From: Poon Elsa <[REDACTED]>
Sent: 2025-05-26 星期一 17:52:29
To: tpbpd/PLAND <tpbpd@pland.gov.hk>; [REDACTED]
Subject: A/YL-SK/415 Respon Comments [Final]
Attachment: Form No. S.16-III_Sep 2023 - P.5 & P.11.pdf; update respon comment.pdf

TPB Ref: A/YL-SK/415

擬在新界元朗石崗丈量約份第 114 約地段 839 號 (部分)、840 號及毗連
政府土地作「擬議臨時商店及服務行業 (為期 3 年)」之用途

Drainage Diagram

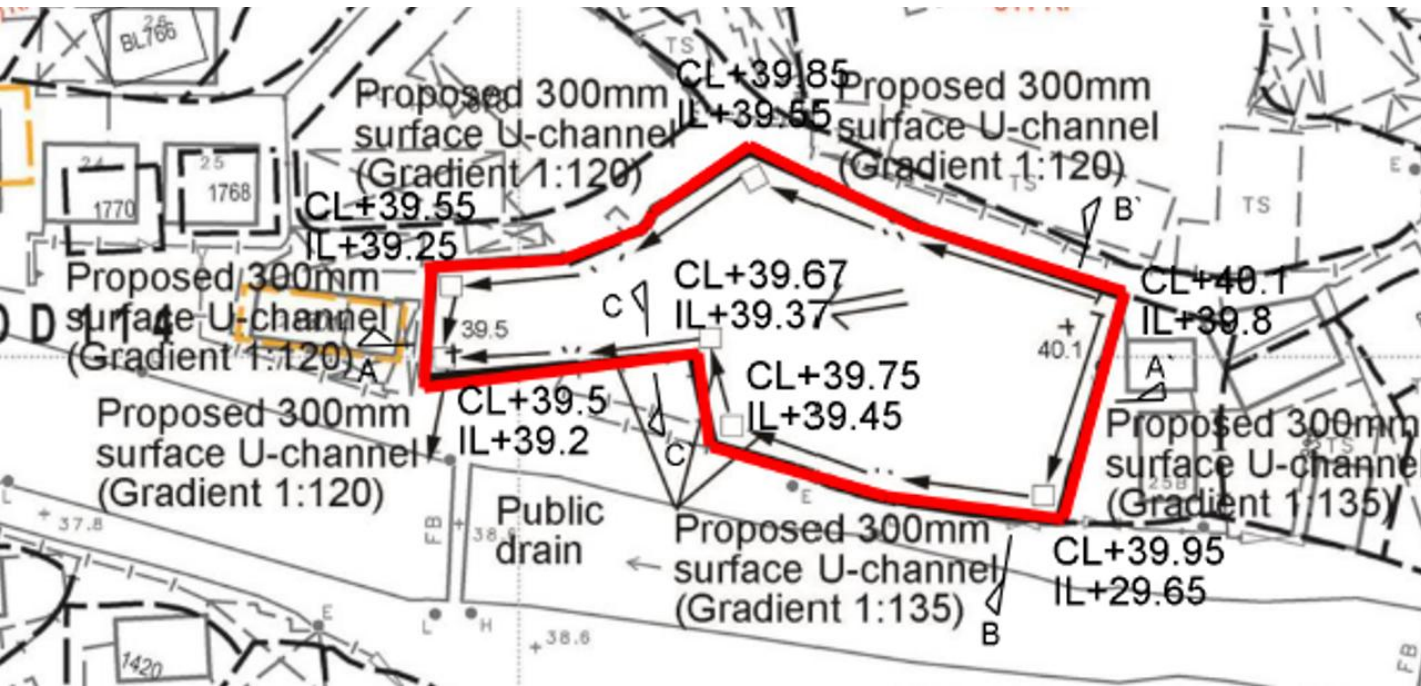
The applicant is required to submit a detailed drainage proposal to support the application.

Subject to the above calculations, it is determined that 300mm surface U-channel which is made of concrete along the site periphery is adequate to intercept storm water passing through and generated at the application site (Figure 1). The intercepted stormwater will then be discharged to the existing public drain via the proposed 300mm surface U-channel outside the application site to the south of the application site for dissipation. (Figure 1)

The calculations in Annex 1.3 shows that the proposed 300mm surface channel has adequate capacity to cater for the surface runoff generated at the subject site and the external catchment. A sand trap will be proposed at the terminal catchpit.

Please see the details. on “**Drainage Diagram**”
